Human Factors Evaluation of the Tank, Combat
Full Tracked: 105mm Gun, M60

Consulting Report
February 1961

A report of work done in connection with Subtask VIII, FIREPOWER, Task 11-26,
"Methods for Improving Performance in Tank Gunnery"

Work Space Provided for the
Gunner

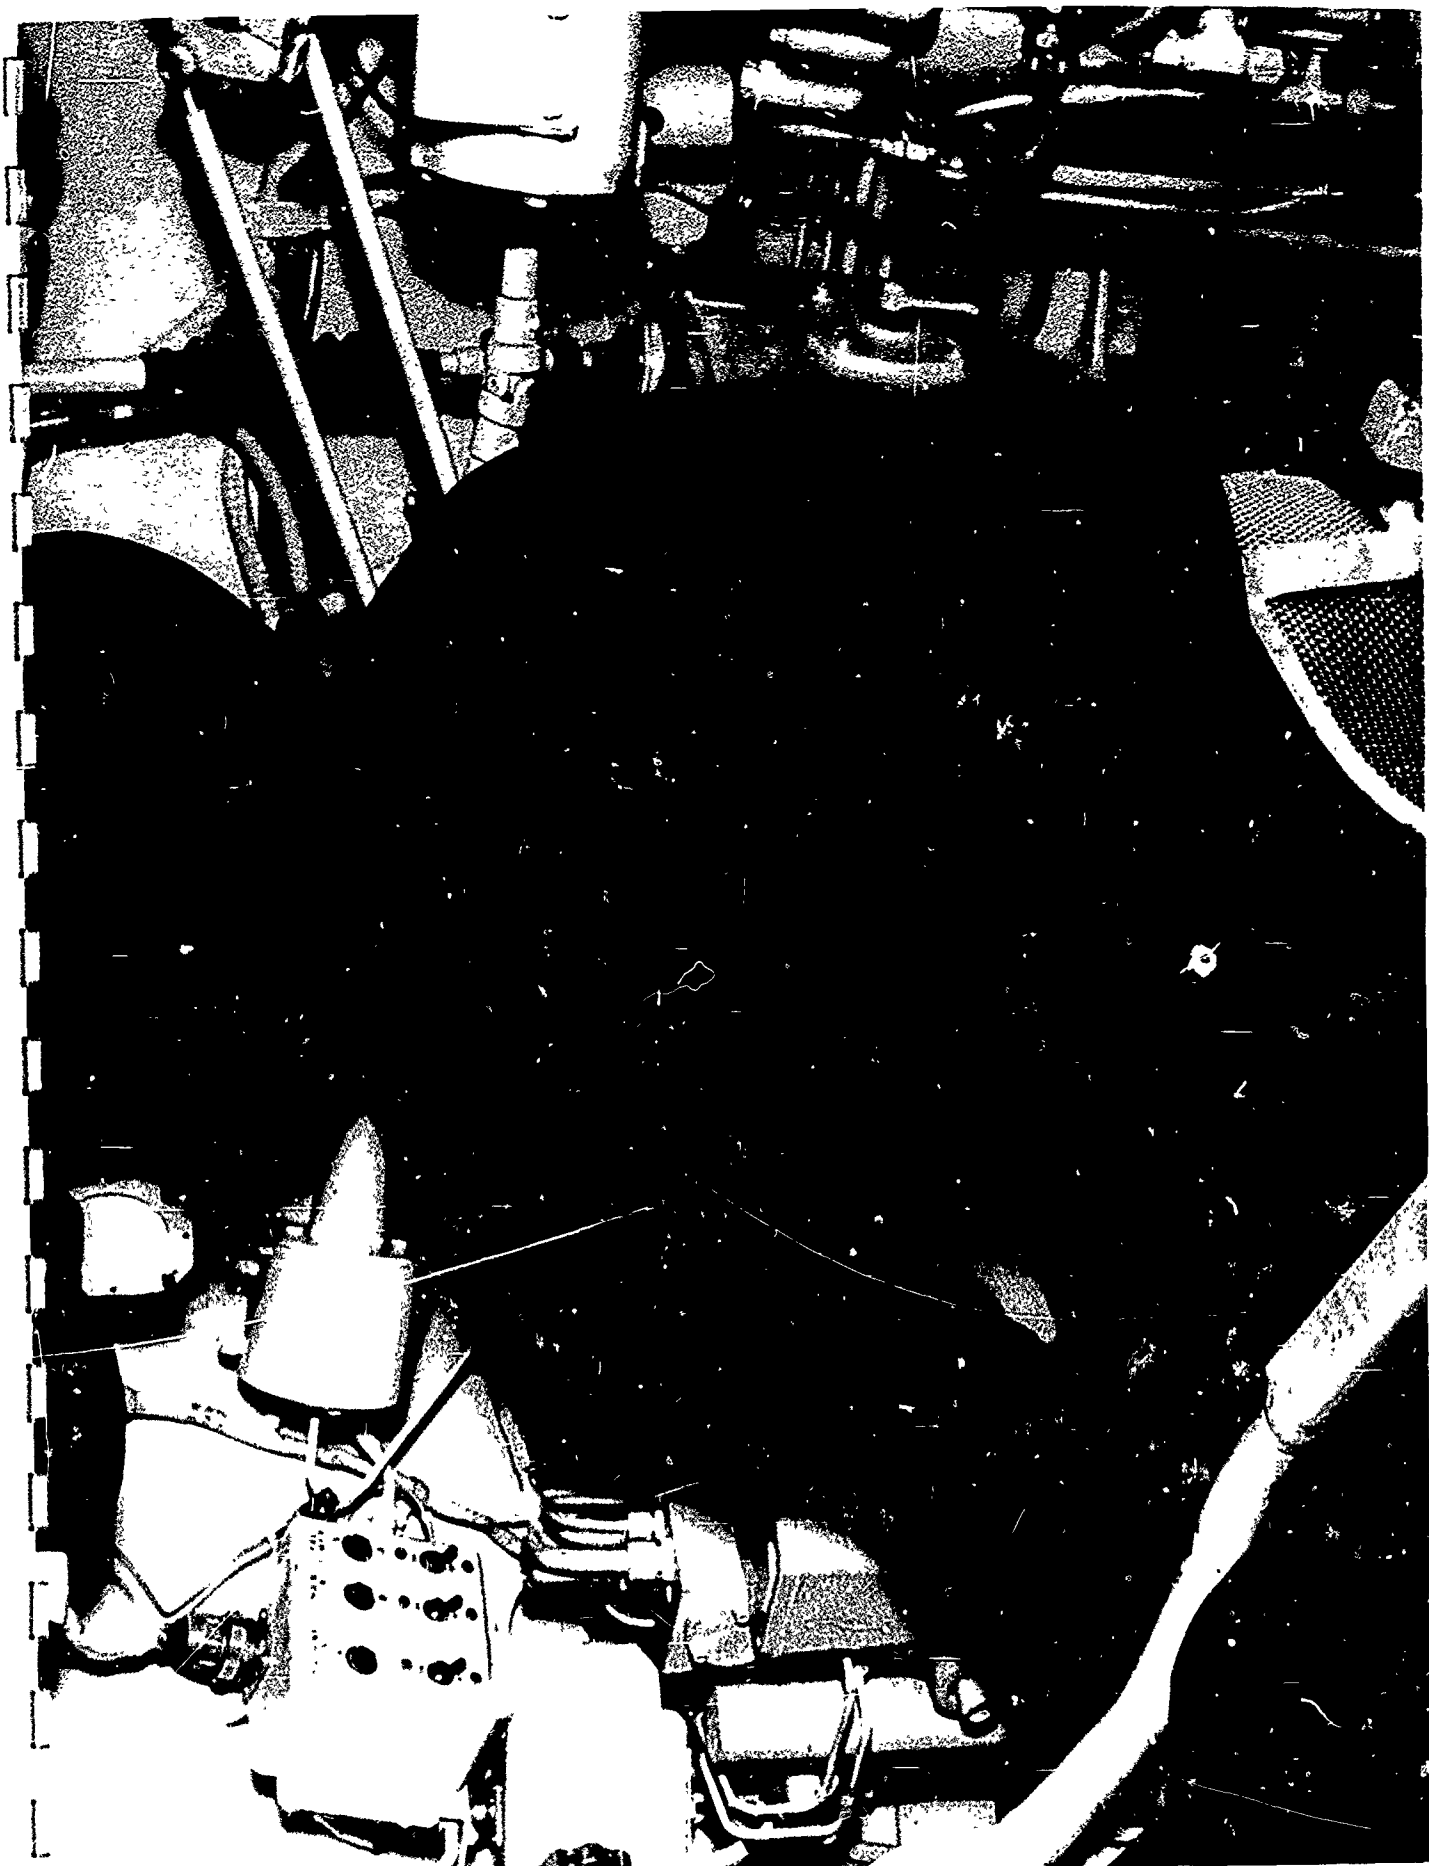
Work Space. The work space provided for the gunner is extremely limited. (See Figure 13.) The gun shield is only a few inches from his left elbow. The ballistic computer is flush against his right hip. He can lean back only slightly because the tank commander's knees are directly behind his back and the range finder is behind his head. And he cannot move very far forward, for equipment is mounted directly in front of him. Restricted to this position, he would suffer from fatigue and cramped muscles after even short periods of operation. The resulting decrement in speed and accuracy of manual performance should be significant. It would be very costly to relocate equipment in the present turret, and to modify linkages and connections; but sufficient operating space for the gunner should be a primary consideration in planning equipment layout for future turrets.

Gunner's Operating Position
Showing Relative Control Locations
and Proximity to the Tank
Commander's Station

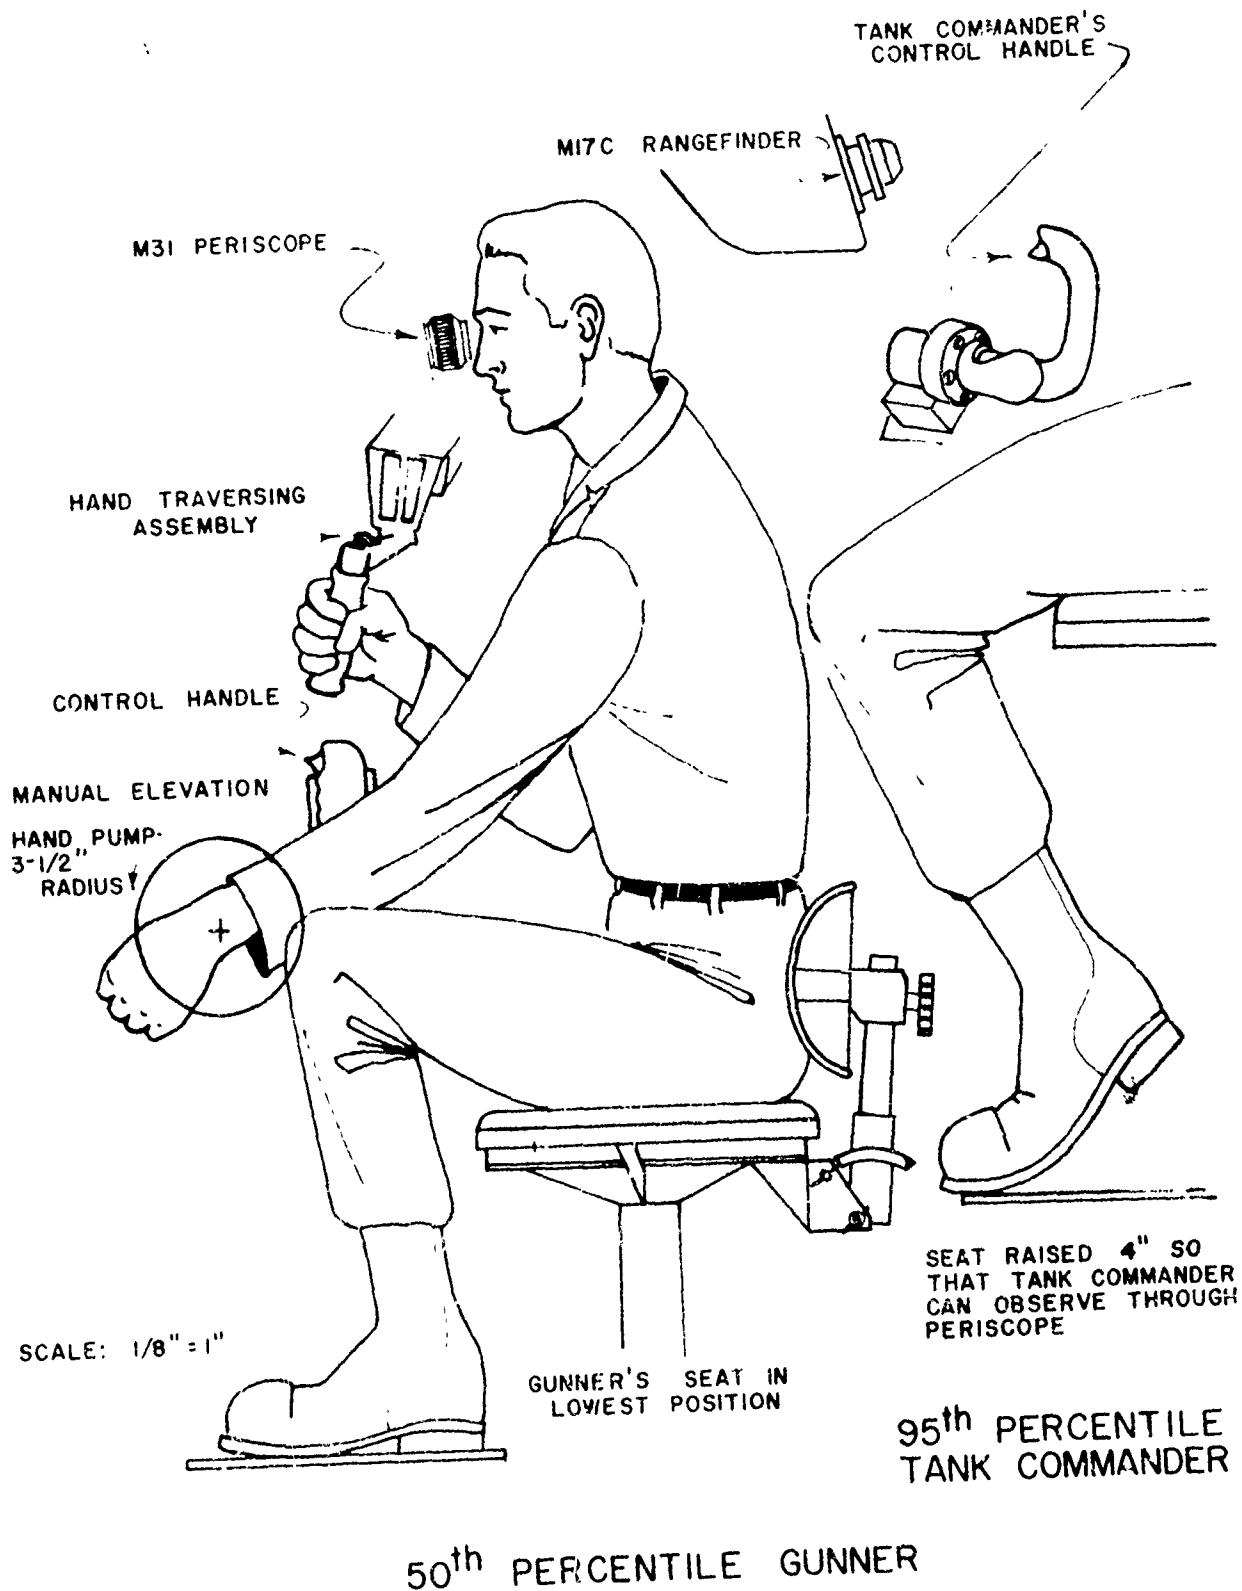
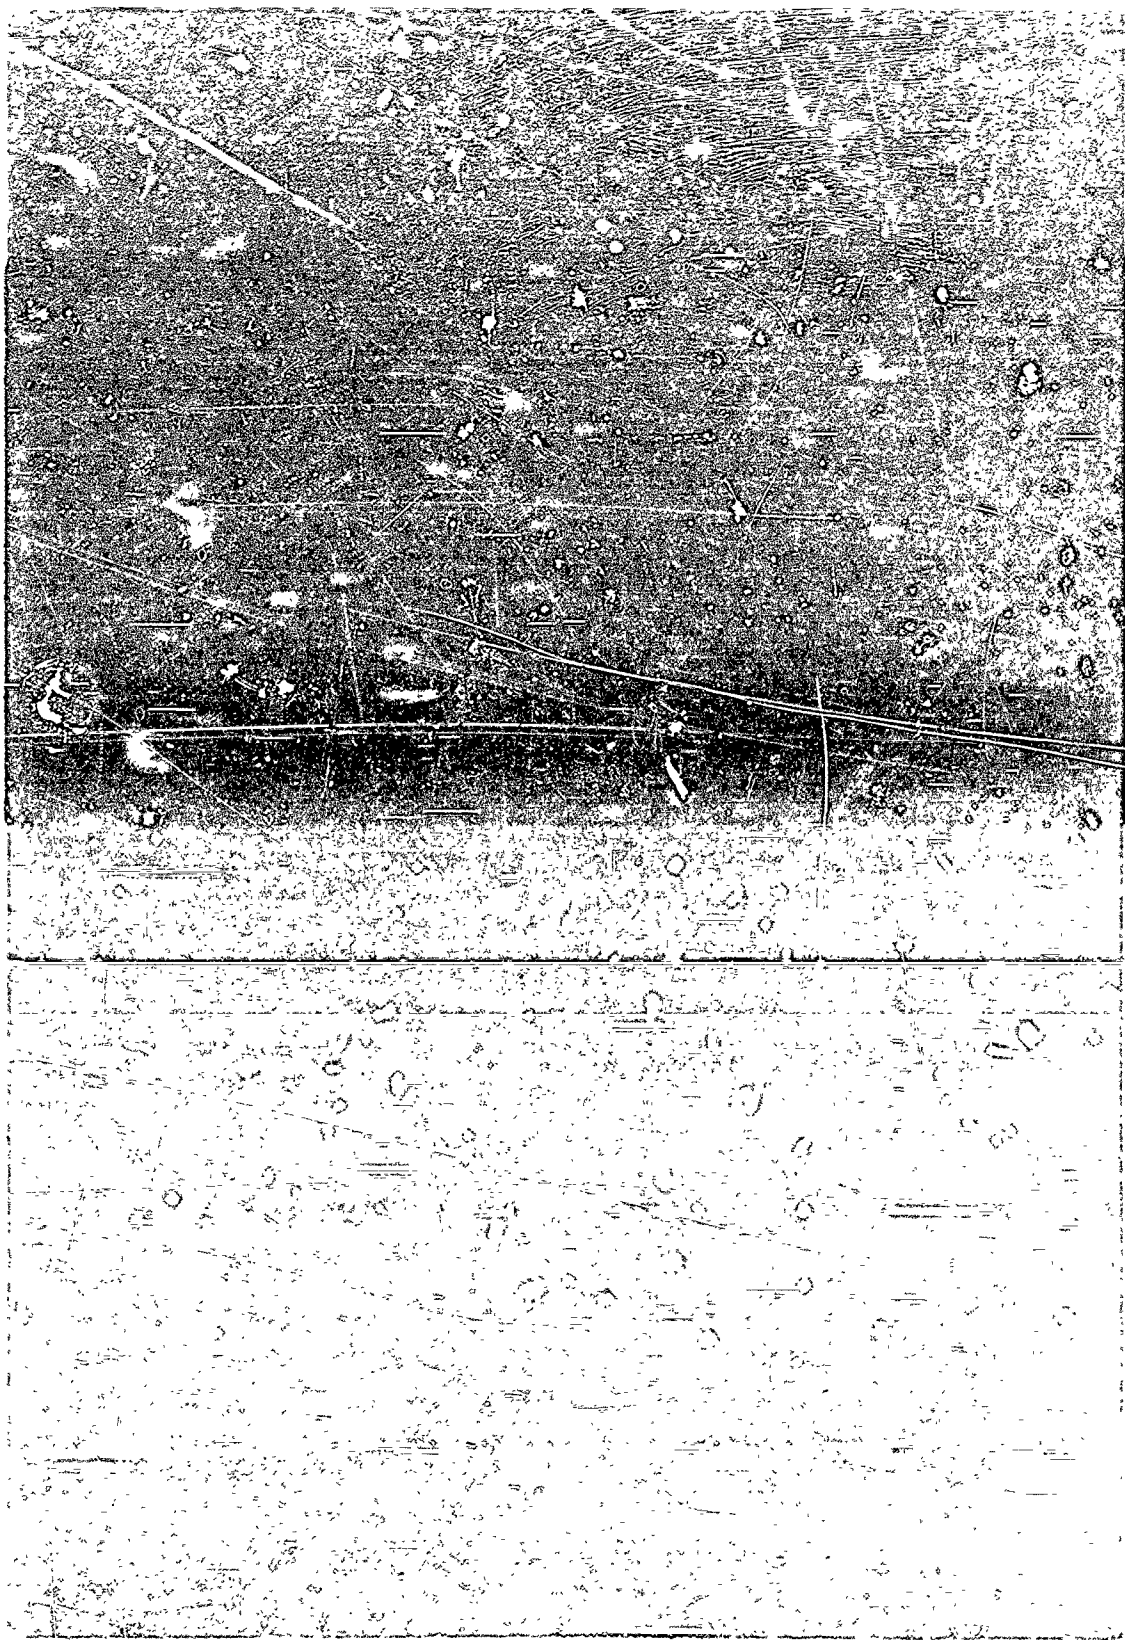
if the elevation hand pump is now located too far from the gunner; this distance requires maximum reach for most gunners, so that the arm is almost fully extended at the far side of the arc. (See Figure 14.) At this point the gunner can apply very little leverage to the pump and cannot maintain continuous smooth operation. At its present height the control also hits the gunner's knee; he is therefore required to move his leg to the left during operation. If the control were moved closer to him, his leg would give much more interference during operation. There is room, however, to raise the pump handle. The control handle should therefore be positioned so that the far arc is no more than 28 inches from the gunner's shoulder, and so that the bottom arc of the hand clears the gunner's leg.

Interference of Mirror with
Lighting for Level Vial of
Elevation Quadrant

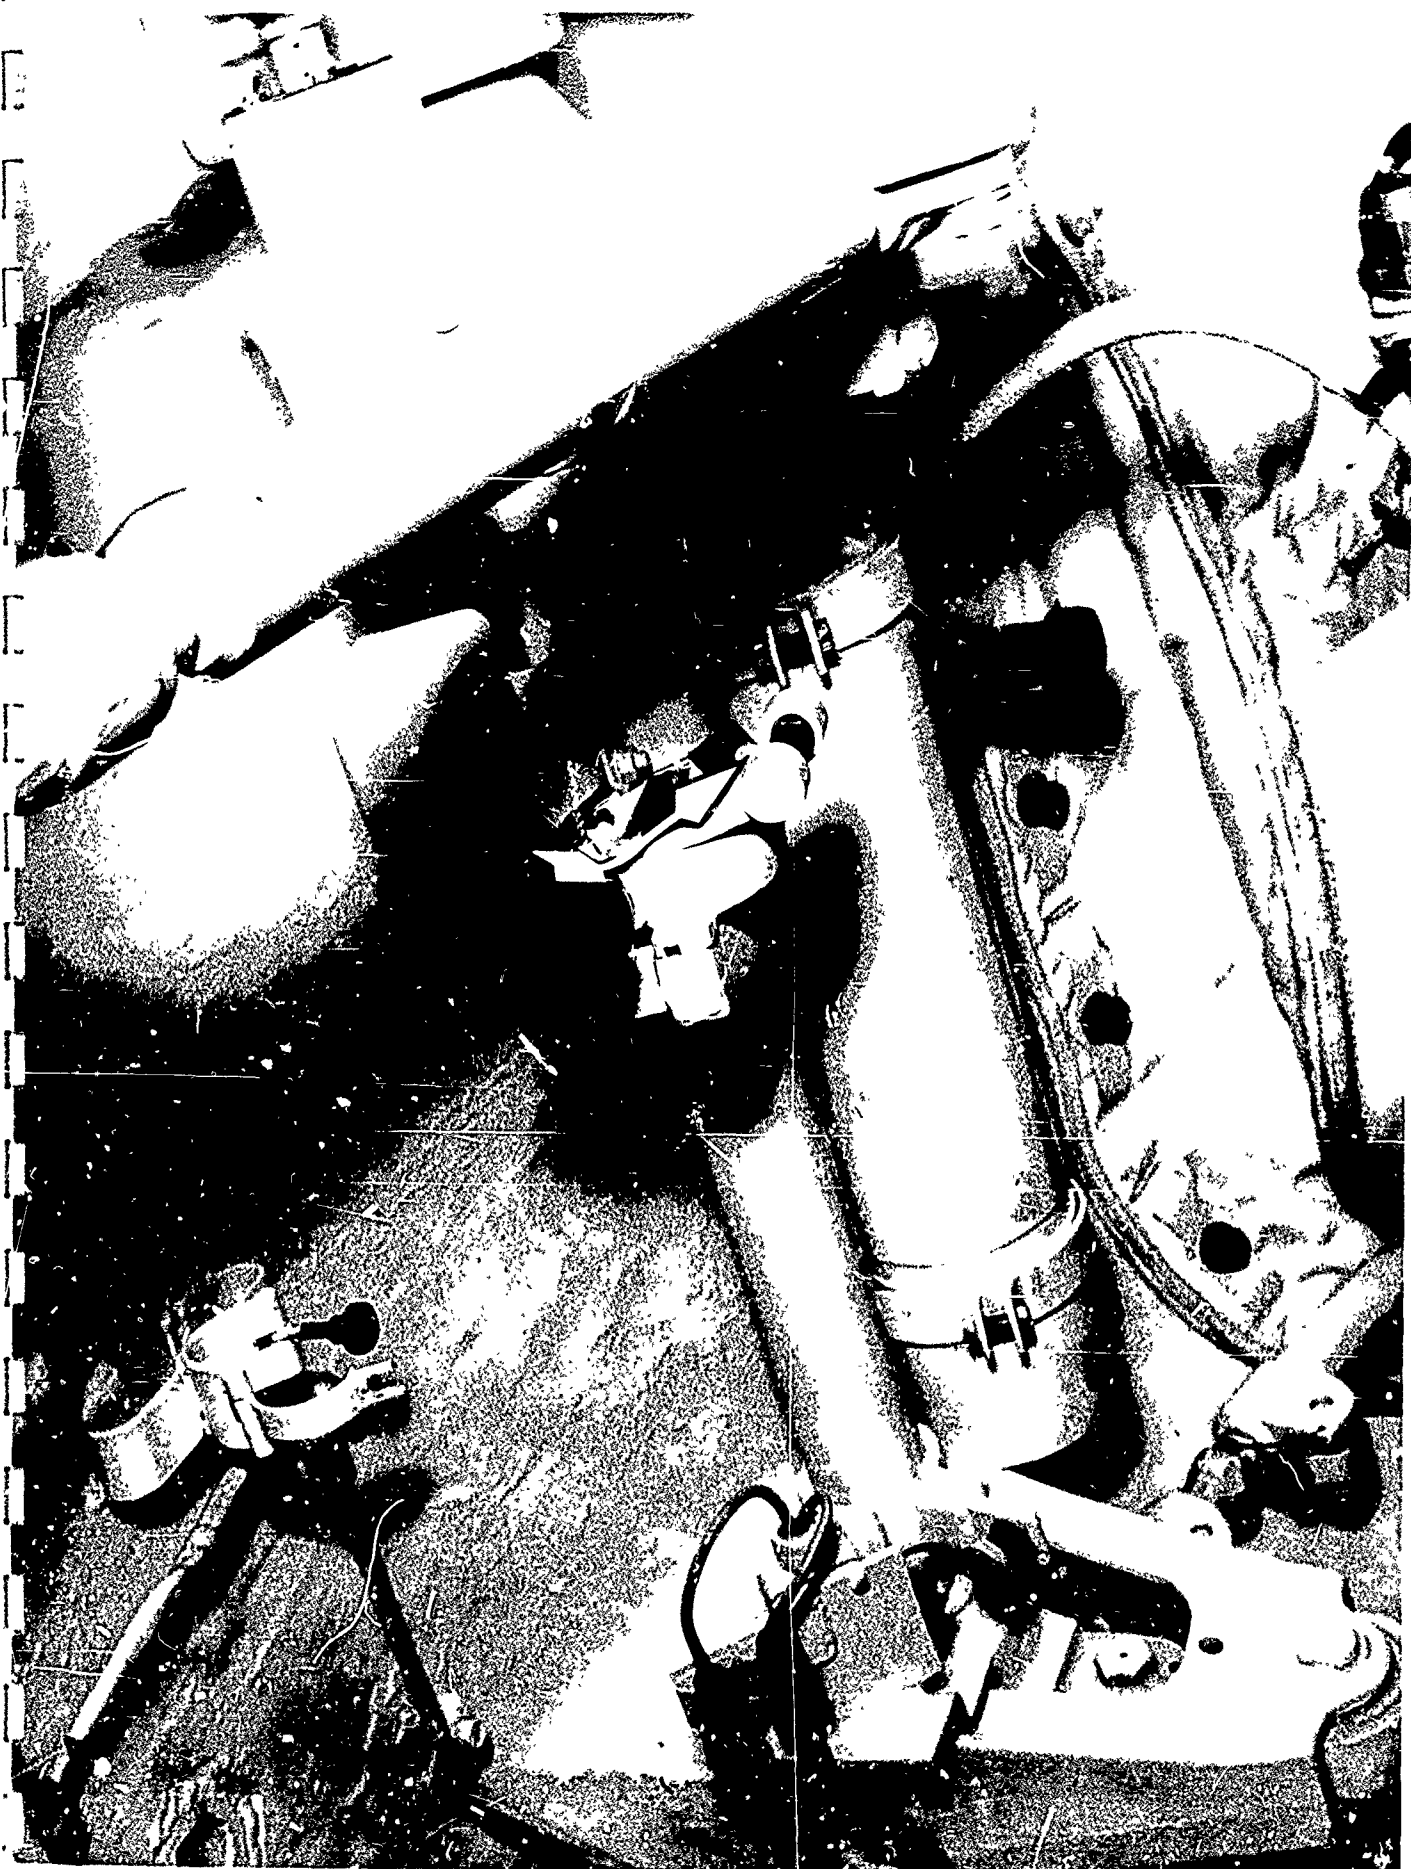
Elevation Quadrant M13. Illumination of the quadrant is very poor. A mirror, mounted between the light and the level vial, blocks all light to the vial and a flashlight is needed to read the quadrant. (See Figure 17.) The ballistic drive light assembly should be moved to a position where it fully illuminates the level vial.
